UNITED STATES PATENT AND TRADEMARK OFFICE

APPLICATION NO.	FILING DATE	FIRST NAMED INVENTOR	ATTORNEY DOCKET NO.	CONFIRMATION NO.
10/815,581	03/31/2004	Michael J. Antal JR.	UOHIP006D1	9383
22434	7590	08/09/2005	EXAMINER	
BEYER WEAVER & THOMAS LLP P.O. BOX 70250 OAKLAND, CA 94612-0250			NECKEL, ALEXA DOROSHENK	
			ART UNIT	PAPER NUMBER
			1764

Office Action Summary

DETAILED ACTION

Figure 2. Schematic of the laboratory reactor.

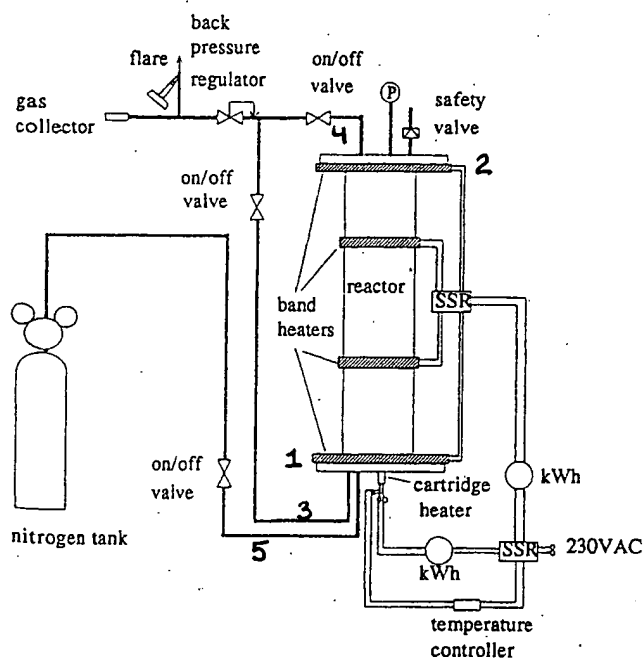
With respect to claim 20, Antal Jr. et al. discloses a reactor (figure 2) which comprises a housing (pressure vessel) with a sealable opening (pressure-tight hinged closure) for receiving a removable canister with a lid; heaters which heat the distal end (2) of the canister (fig. 2) (page 653, col. 2, paragraph under "Apparatus and Experimental Procedures"); a first valved exit orifice (3) at a proximal end (1) and a second valved exit (4) orifice at a distal end (2) of the housing (pressure vessel); and a valved entry orifice (5) at the proximal end (1) (page 653, col. 2, paragraph under "Apparatus and Experimental Procedures").

Figure 2 of Antal Jr. et al. does not provide reference numbers, so the examiner has numbered various elements below to provide further clarification of how the reference has been applied.

With respect to claim 22, Antal Jr. et al. further discloses wherein a flare (burner) is in communication with the second valved exit (4) (see figure 2).

With respect to claim 24, the schematic illustration of Antal Jr. et al. has been applied so that the proximal end (1) is at the bottom and the distal end (2) is at the top of the vertically arranged device shown in figure 2. The device of Antal Jr. et al. arranged so that the proximal end (1), and its associated elements, is at the top while the distal end (2), and its associated elements, is at the bottom of the vessel would still be the same apparatus (only turned on end). It appears from the description of the operation of Antal Jr. et al.'s device, that in such an orientation, the device would continue to be operational. It has been held that there is no invention in shifting the location of parts when the operation of the device would not thereby be modified. In re Japikse, 86 USPQ 70 (CCPA 1950).

The schematic of the apparatus of Antal Jr. et al (figure 2) only illustrates that the valved entry (5) passes into the proximal end (1) but fails to illustrate if it extends into the canister.
